RFP 2016-0009 - ADDENDUM 3

COLIGNY REDEVELOPMENT PROJECT

Town of Hilton Head Island, South Carolina

Date Issued: August 5, 2016

SHEET NUMBER L-103B

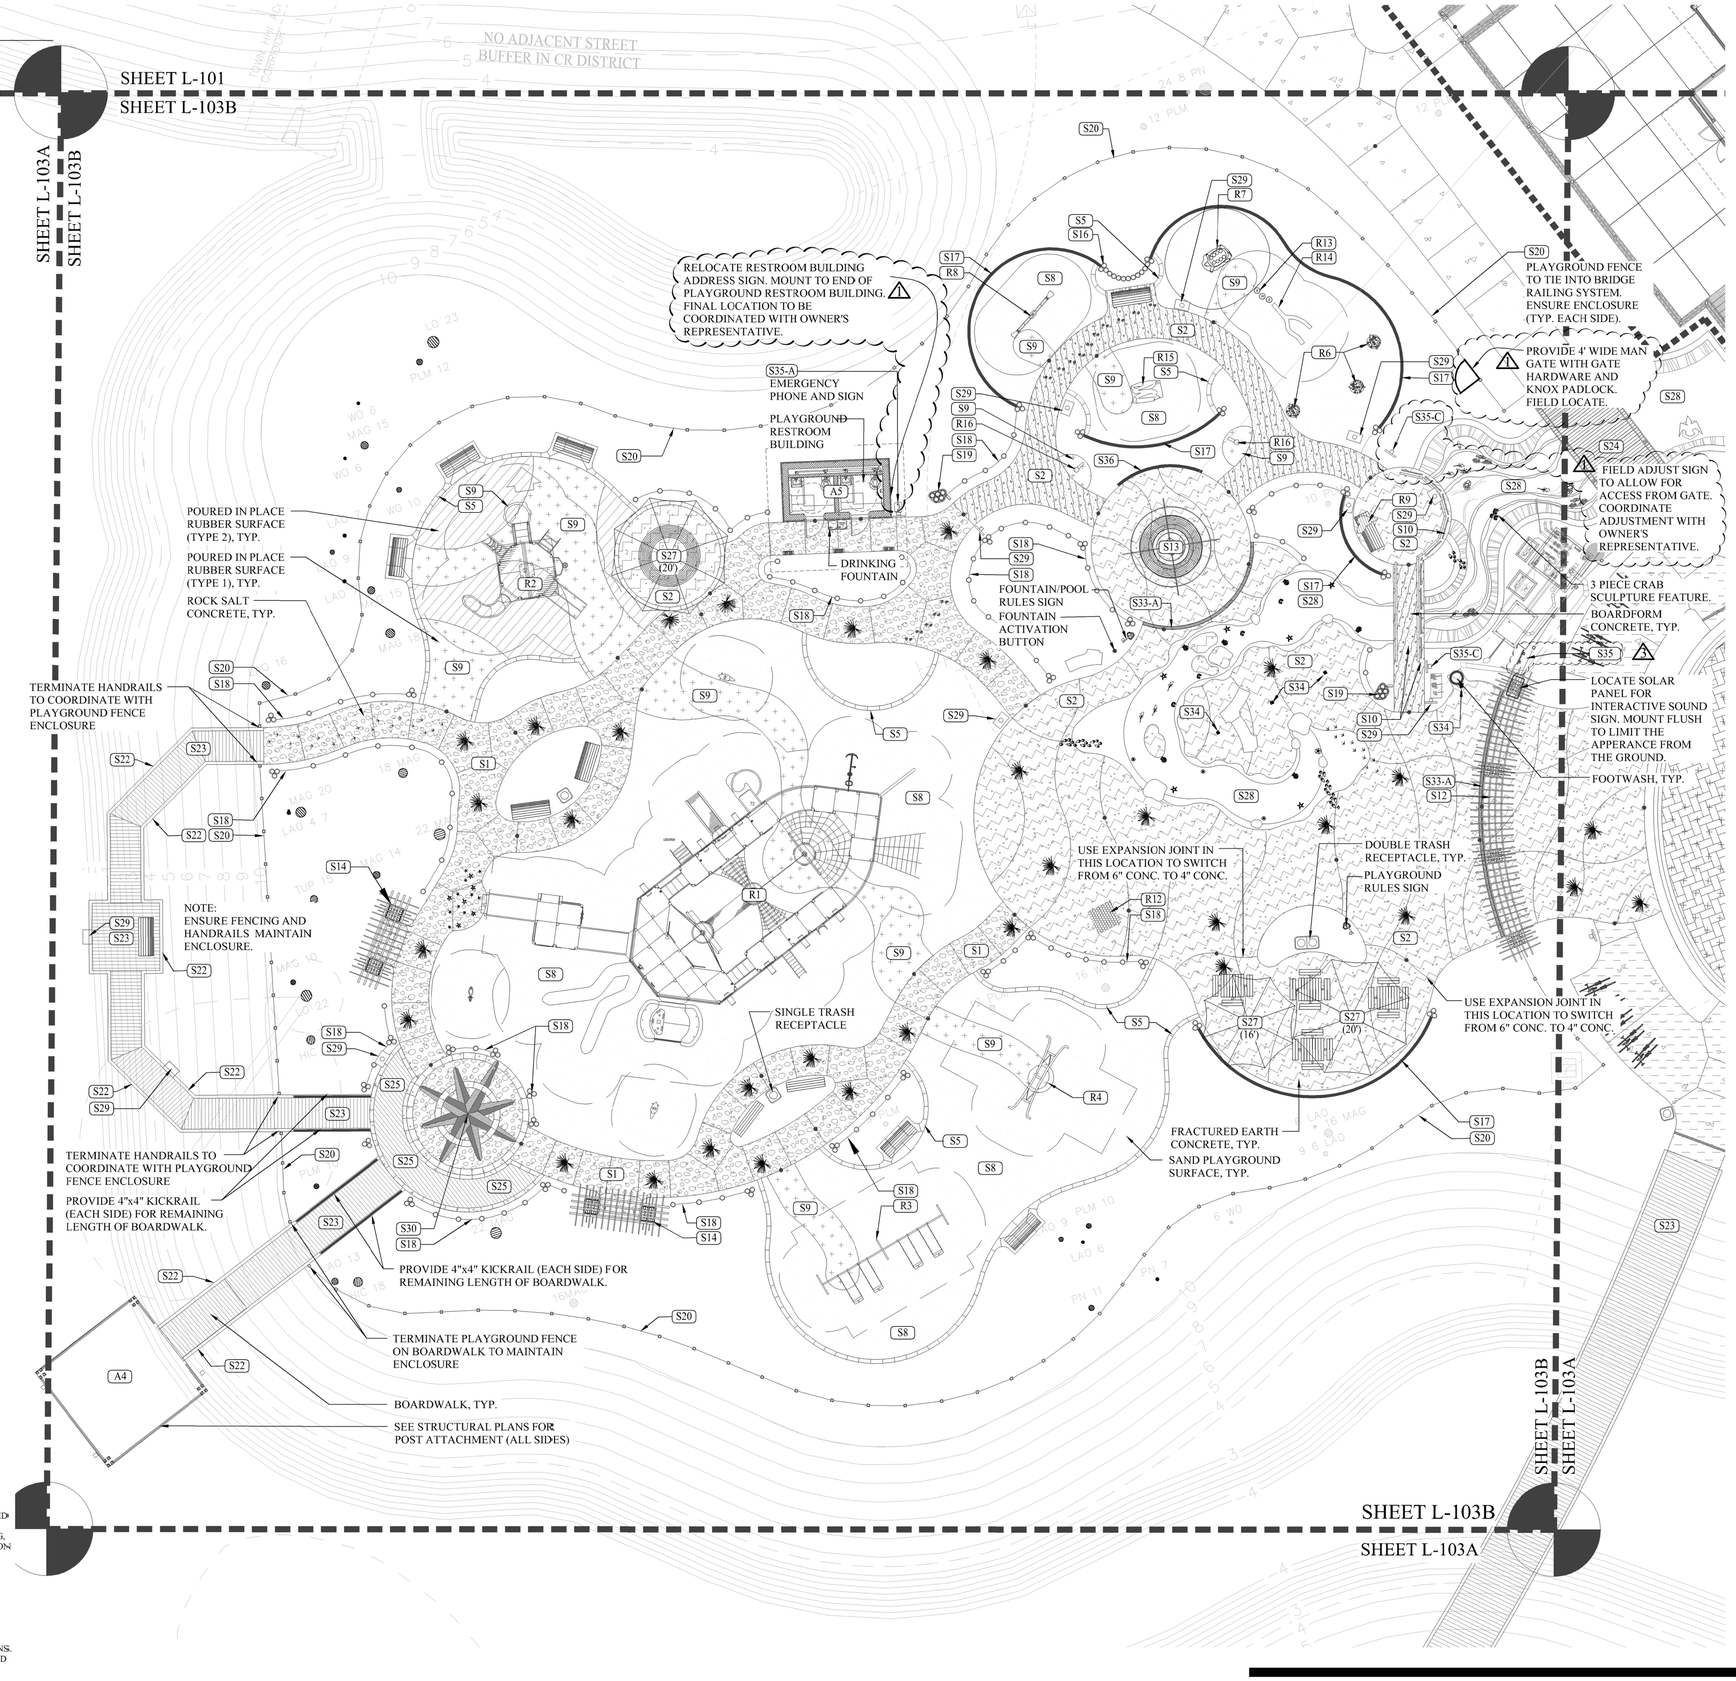
3.1 SHEET L-103-B

A. Has been modified to add a Pool Emergency Cut-off switch sign with shunt trip button adjacent to fountain pool equipment.

5 / L306 I.D. / INCIDENTAL SIGNS / POOL EMERGENCY CUT OFF SIGN
SCALE: 3/4" = 1'-00"

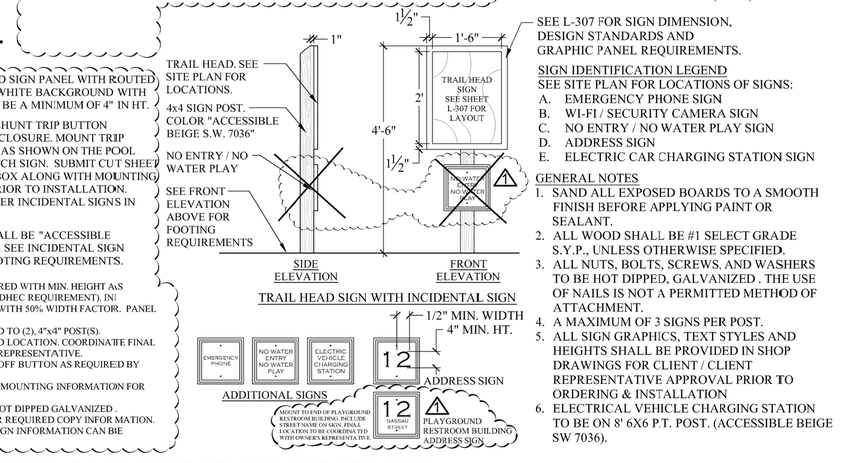
3.2 SHEET L-306

A. Detail 5 has been modified to add a Pool Emergency Cut-off sign with shunt trip button and emergency phone device mounted to an 8x8 post.

SHEET NUMBER
L-401

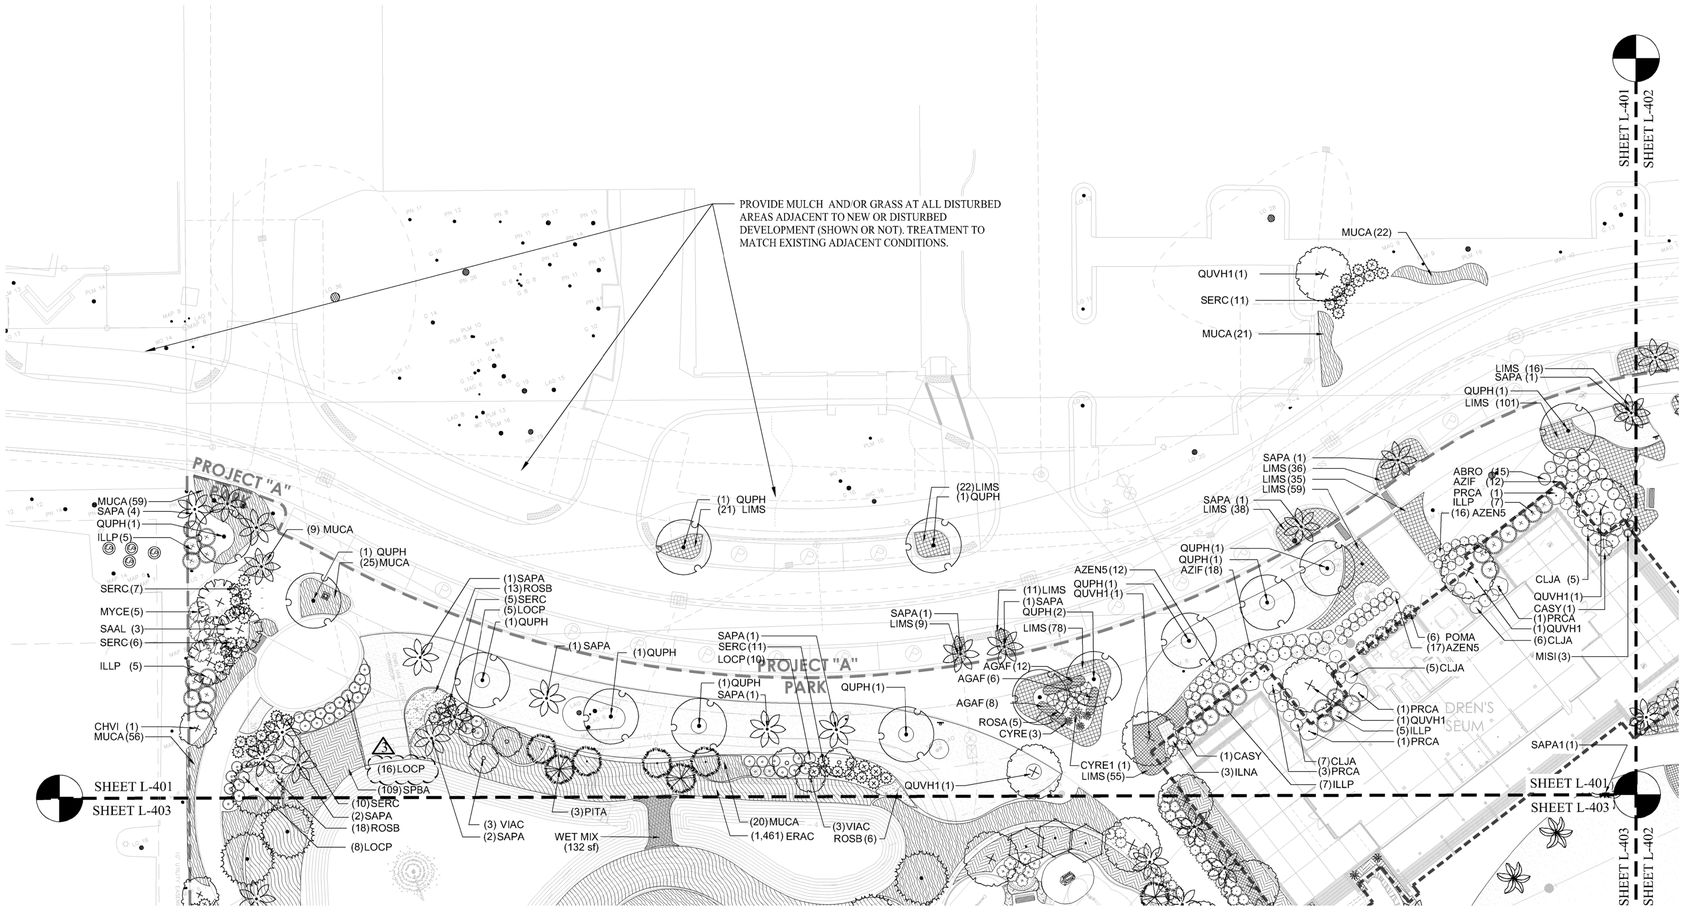
3.3 SHEET L-401

A. Has been modified to include landscape revisions

SHEET NUMBER
A1.101

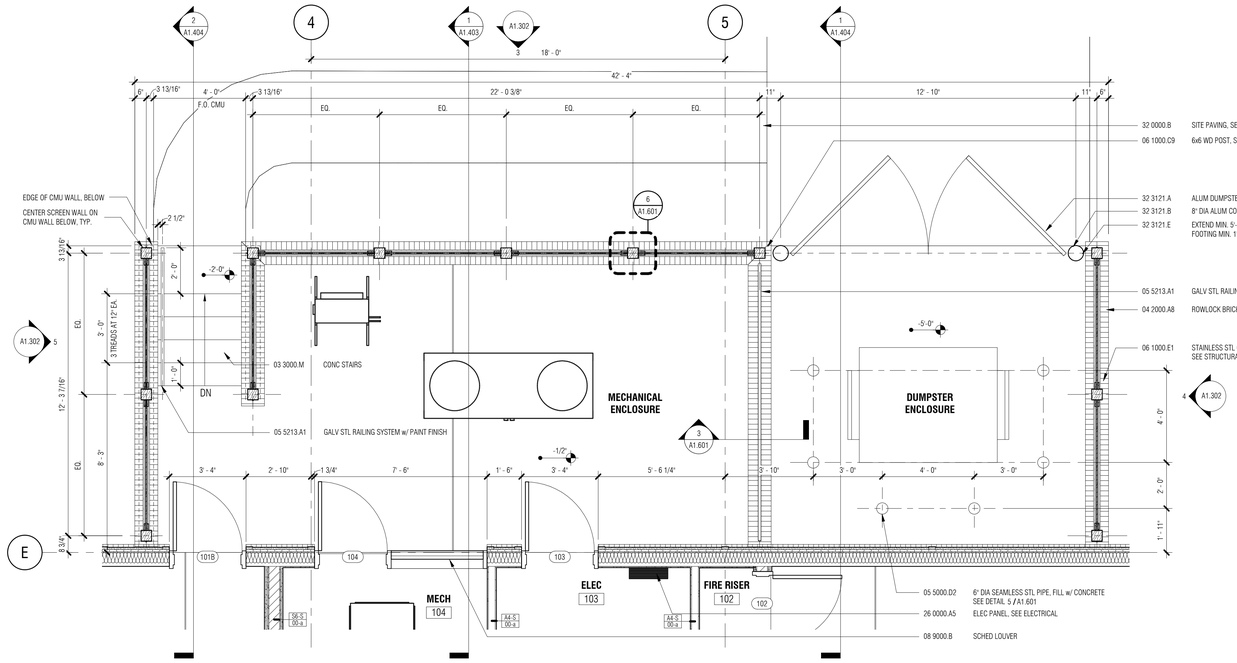
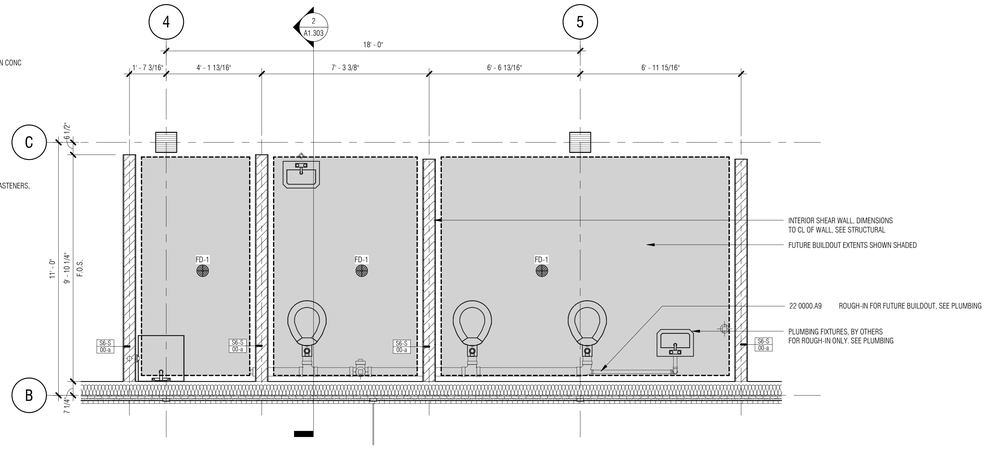
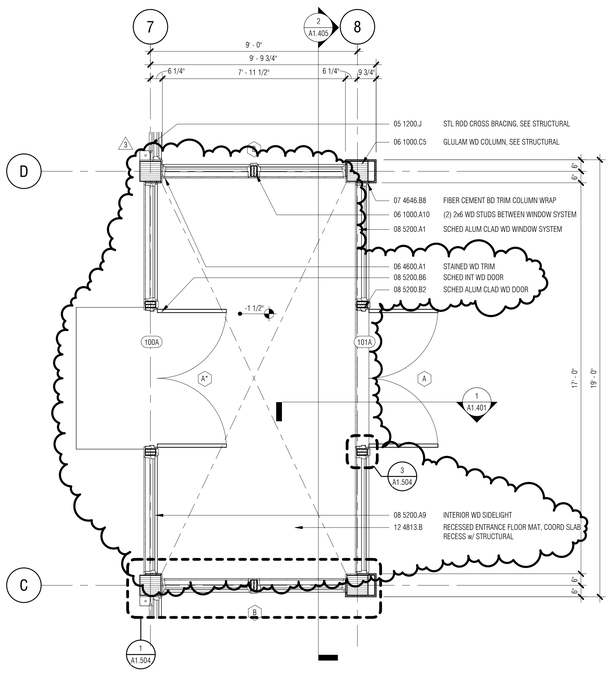
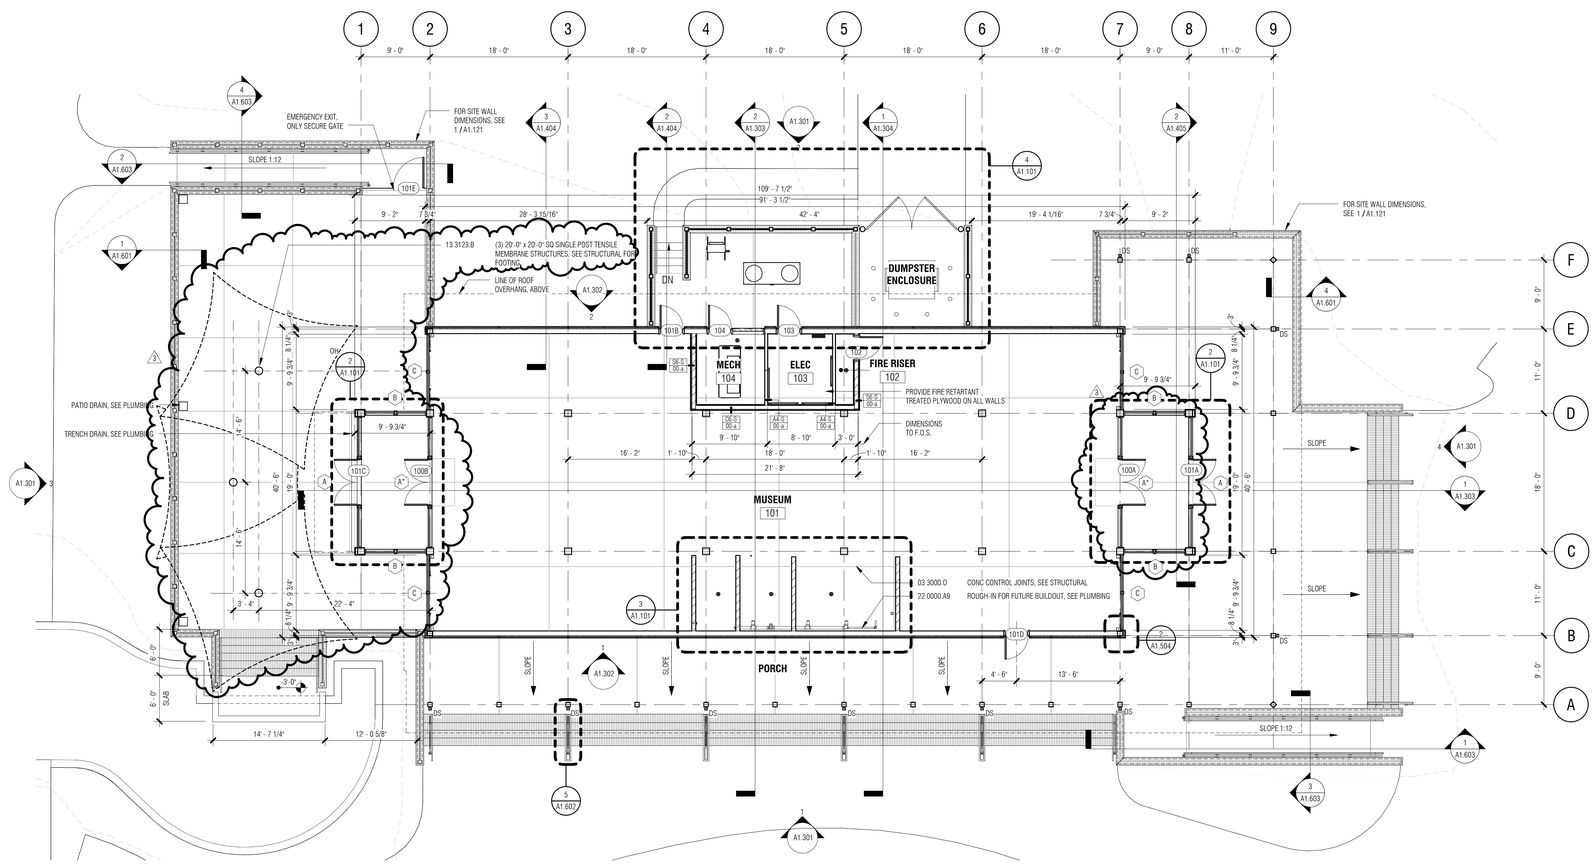
3.8 SHEET A1.101

A. Added Door 100A and stained wood trim at north entrance
B. Added Door 100B and stained wood trim at south entrance
C. Added shade structures and foundations at playground area outside
   1. south entrance.
D. Added recessed entrance mats at both entrances

SHEET NUMBER
A1.102

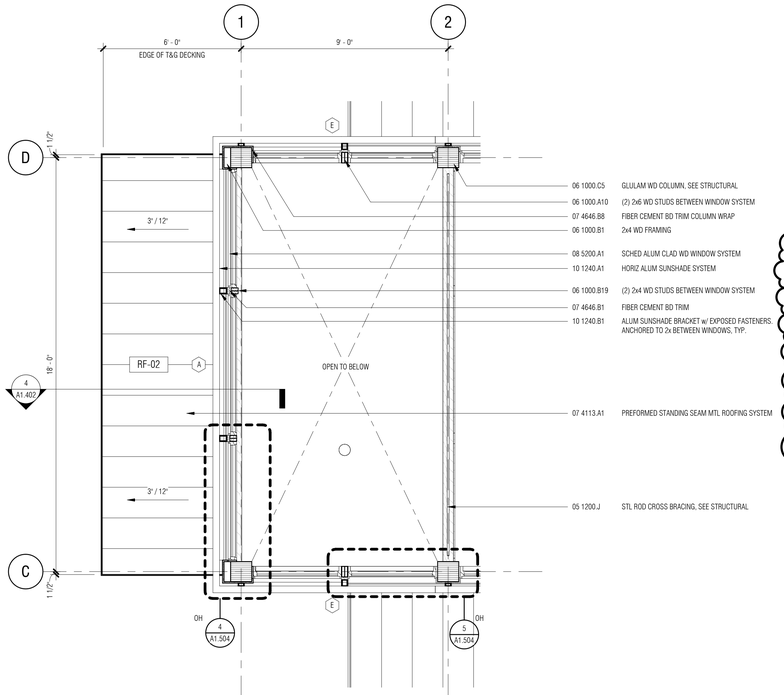
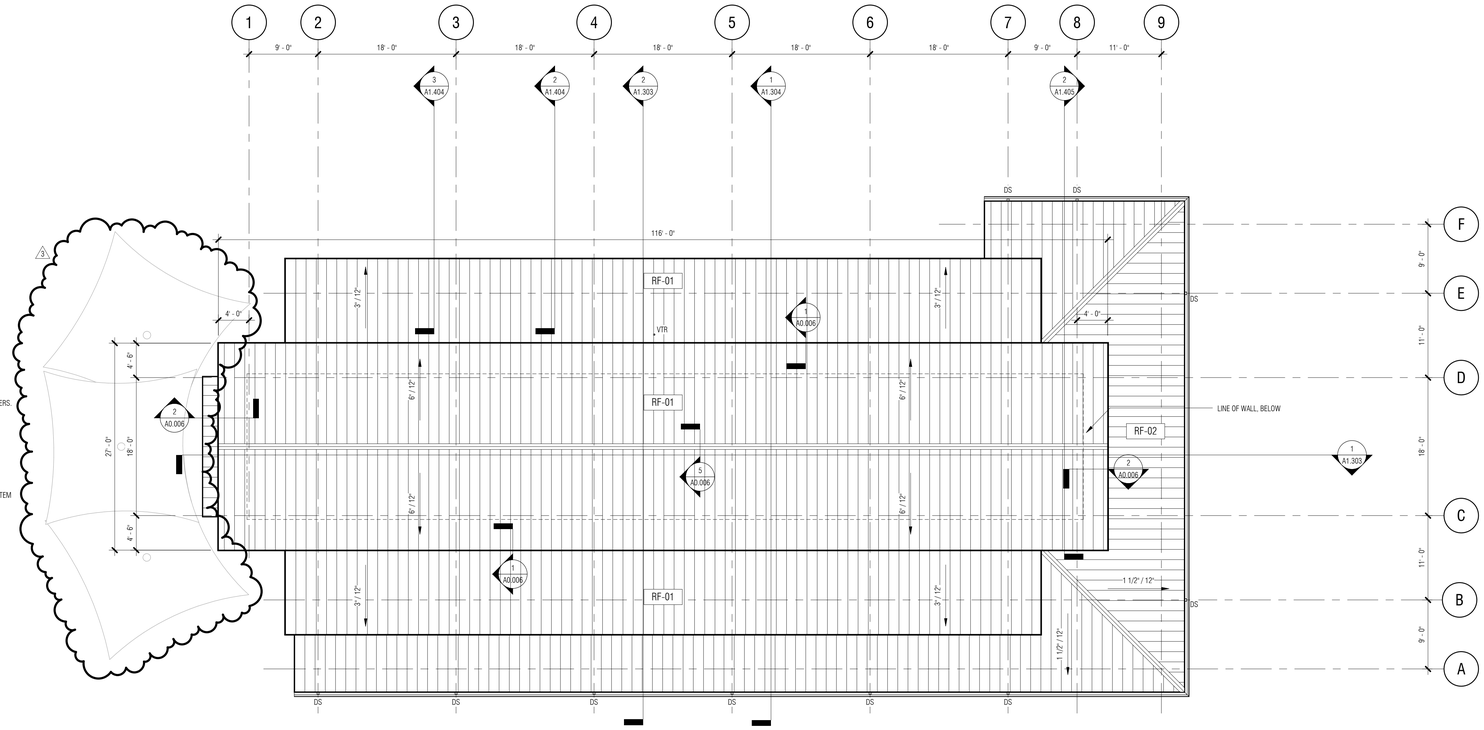
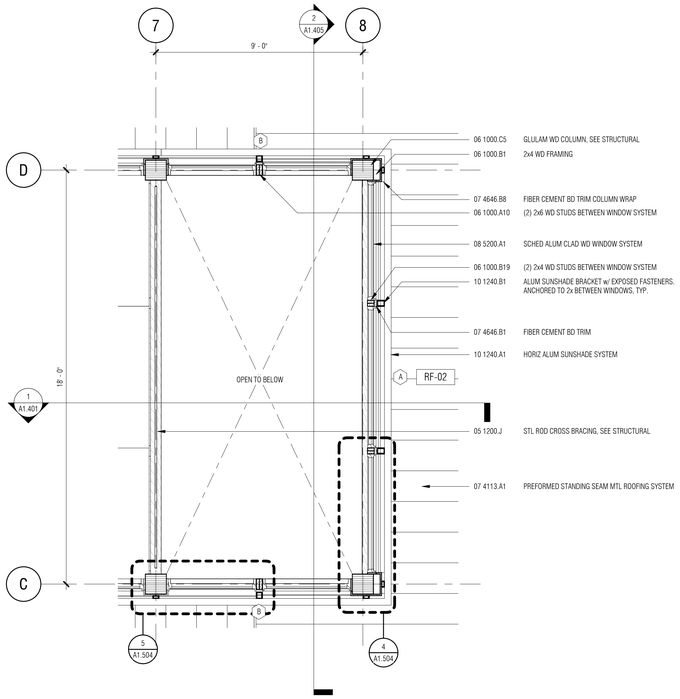
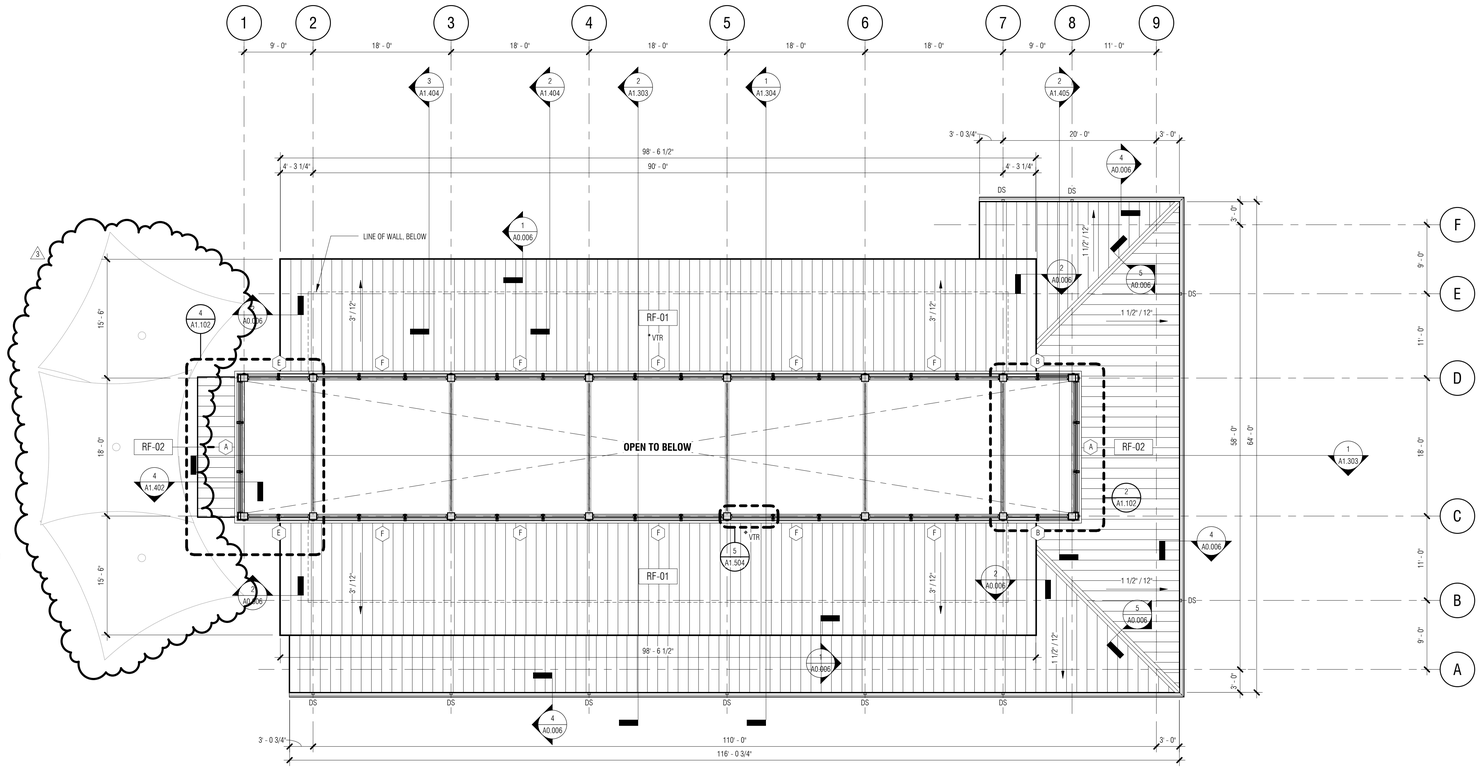
3.9 SHEET A1.102

A. Added shade structures and foundations at playground area outside
   1. south entrance.
